Docket Item # 7 & 8
BAR CASE # 2011-0275 & 0276

BAR Meeting
October 19, 2011

ISSUE: Permit to Demolish/Encapsulate, Dormer Additions and Alterations
APPLICANT: Mark Eisenhower and Amy Fries by Dimond Adams Design Architecture
LOCATION: 101 Franklin Street
ZONE: RM / Residential

Figure 9. Proposed north (rear) elevation and proposed streetscape on Union Street.

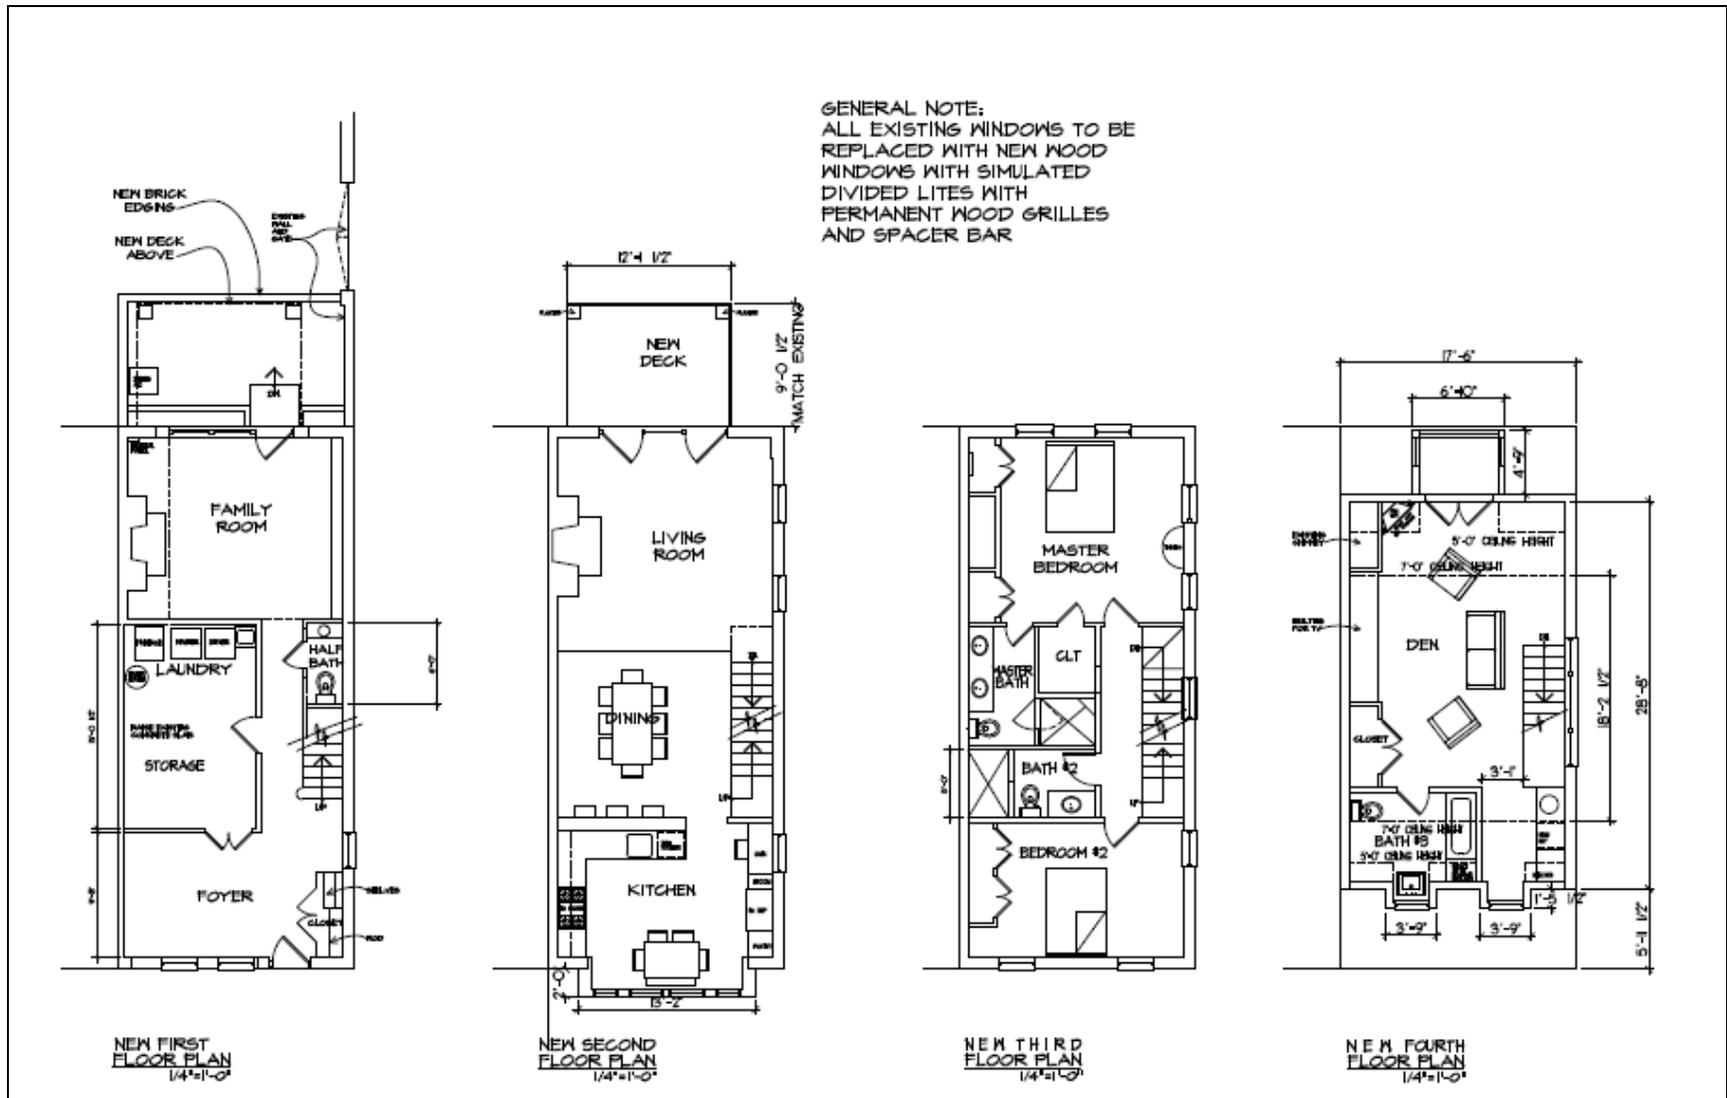
However, Staff is concerned that the dormer with covered porch on the north (rear) elevation, as proposed, overwhelms the existing building. The dormers on the original proposal had a gable roofed and the applicant made them hip roofed, at Staff's recommendation, to reduce their size but the dormer on the north still appears very large. Staff supports a dormer on this elevation, and even a small outdoor porch element, but finds that the extended roof of the porch to the rear building wall adds too much mass and visual weight when viewed from the street below. Staff believes that this dormer will set an example for BAR applications for other dormers in this development and therefore believes this is an opportunity to create an appropriate dormer with a small deck that is open to the sky.

There are more than a few examples of less-than-successful dormers in the district, some of which were not reviewed by the BAR. Historically, dormers were single features often with windows smaller than those on the floors below. Today, because of the desire to maximize habitable area and views of the Potomac River, the proposals often involve large dormers—shed dormers with triple windows, "Palladian"-style dormers, and the like. Staff does not object to the size nor the use of a pair of French doors on this dormer but finds that the covered porch and columns should be removed. This will still permit a small outdoor area with simple railing and significantly minimize the apparent bulk and mass of this element.

1. That the new and replacement windows be in conformance with the Window Policy; and,
2. That the columns and roof for the covered portion of the rear (north) dormer be removed to reduce the bulk and mass of the dormer.
